UNITED STATES PATENT AND TRADEMARK OFFICE

APPLICATION NO.	FILING DATE	FIRST NAMED INVENTOR	ATTORNEY DOCKET NO.	CONFIRMATION NO.
10/561,526	12/20/2005	Kenji Ookura	P28917	9812
7055 7590 08/16/2007 GREENBLUM & BERNSTEIN, P.L.C. 1950 ROLAND CLARKE PLACE RESTON, VA 20191			EXAMINER GUSHI, ROSS N	
			ART UNIT 2833	PAPER NUMBER
			NOTIFICATION DATE 08/16/2007	DELIVERY MODE ELECTRONIC

Office Action Summary	Application No.	Applicant(s)	
	10/561,526	OOKURA, KENJI	
	Examiner	Art Unit	
	Ross N. Gushi	2833

DETAILED ACTION

Attachment

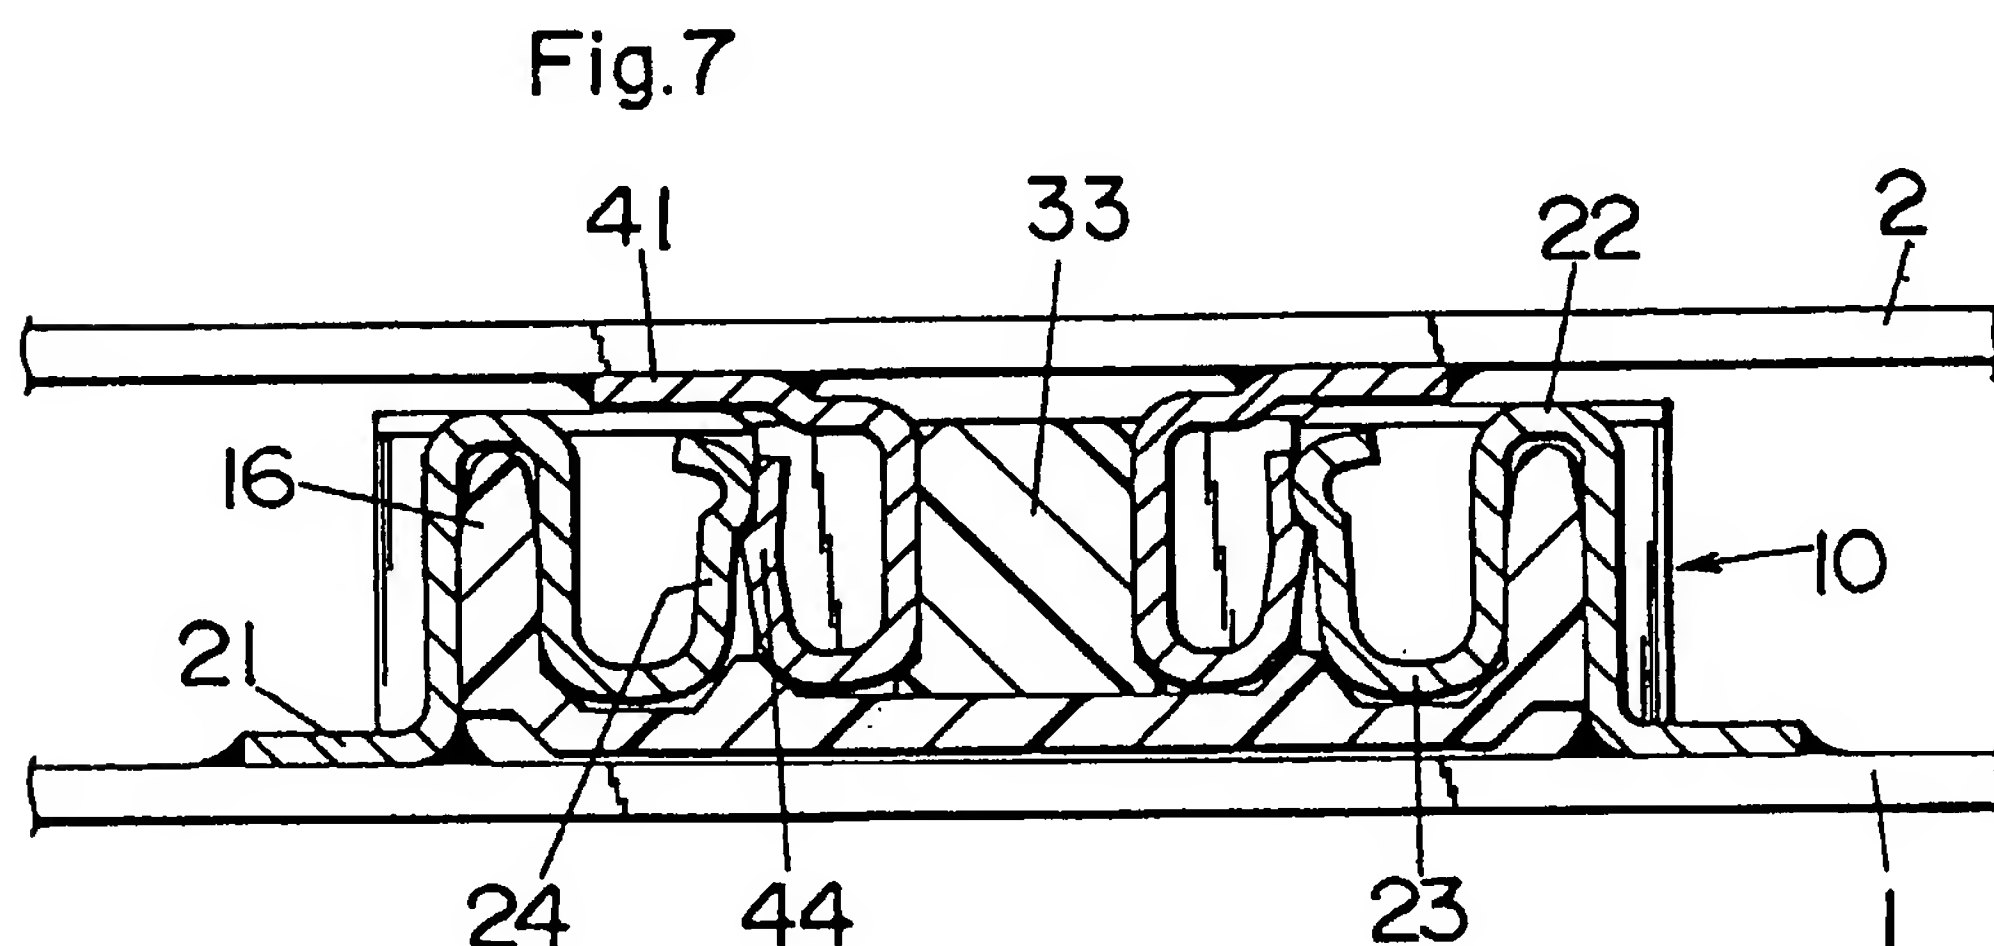
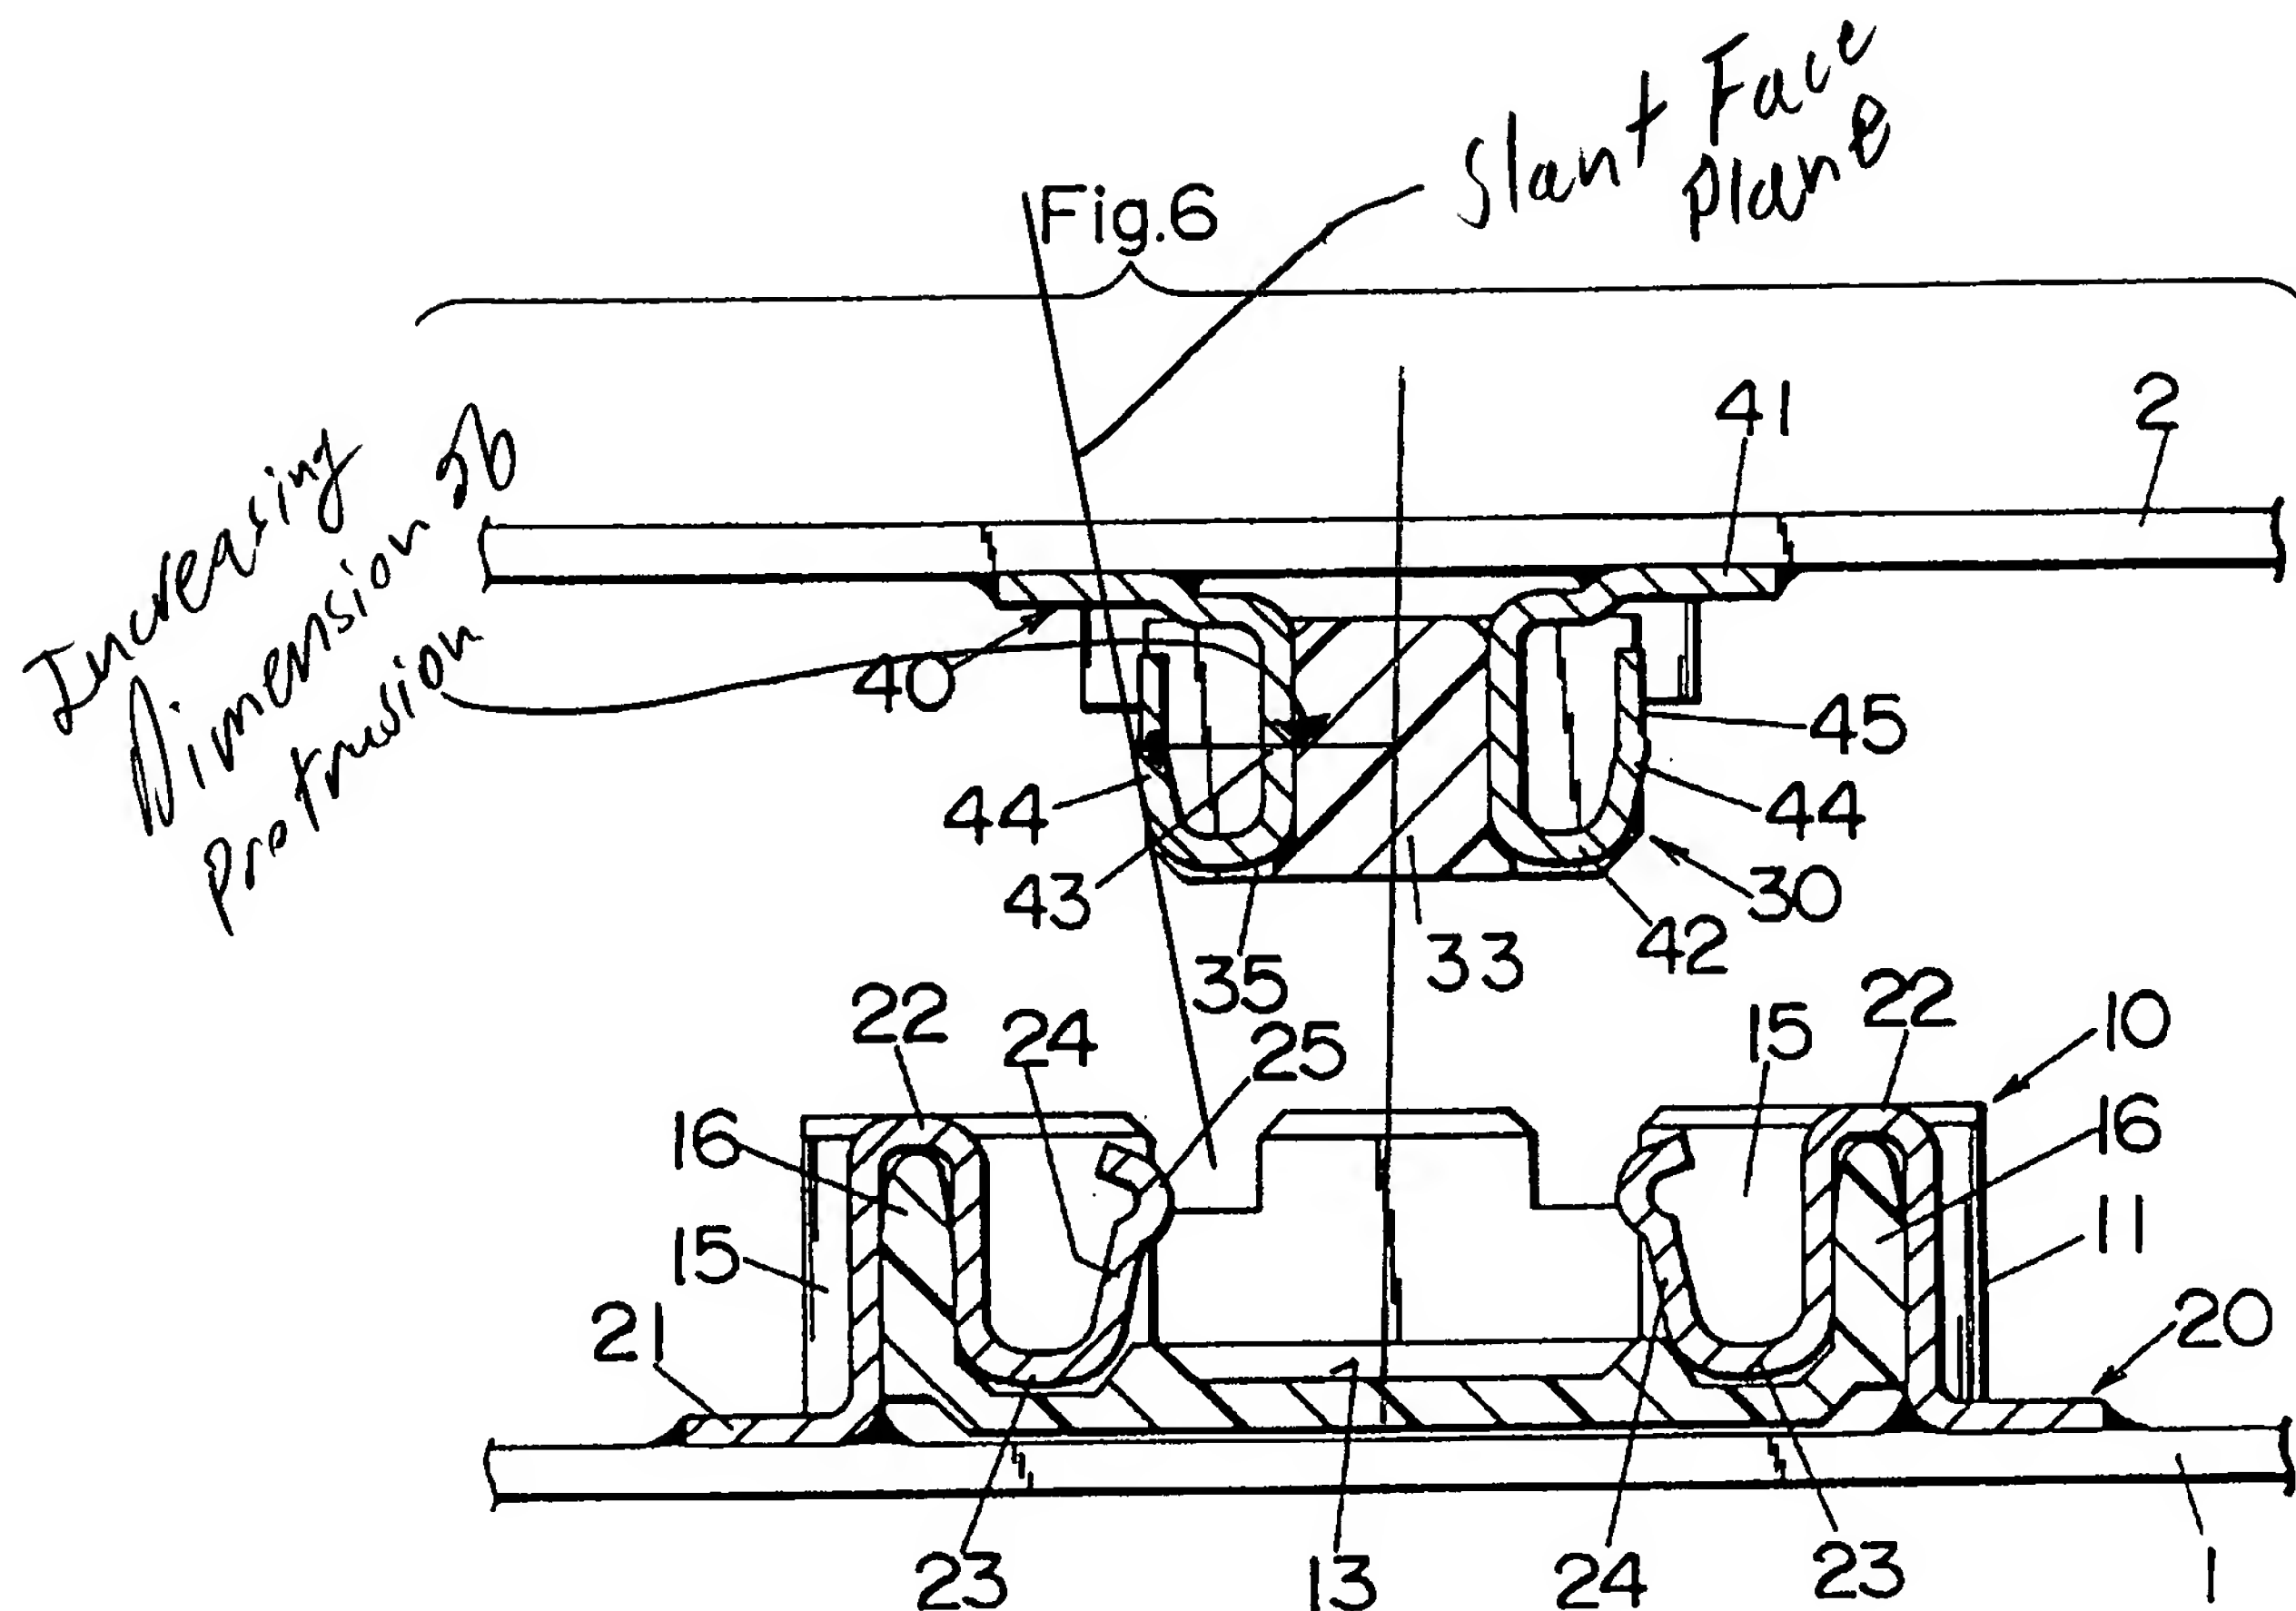
Claims 3, 4, 5, 6, 9, and 10 are rejected under 35 U.S.C. 103(a) as being unpatentable over Igarashi in view of Okura. Per claims 3, 4, 9, and 10 Igarashi does not disclose a protrusion and a concavity. Okura discloses a protrusion and a concavity (see attachment) as claimed. At the time of the invention, it would have been obvious to include a protrusion and concavity on the Igarashi header posts as taught in Okura. The suggestion or motivation for doing so would have been to provide a latching engagement between the connectors as taught in Okura (col. 4 lines 40-46) and as is well known in the art.

Per claim 5, the protrusion comprising a slanted face provided on an outer face of the protrusion so that a dimension of the protrusion becomes larger becomes larger as the slanted face extends towards the second face in a height-wise direction of the header post (see attachment)
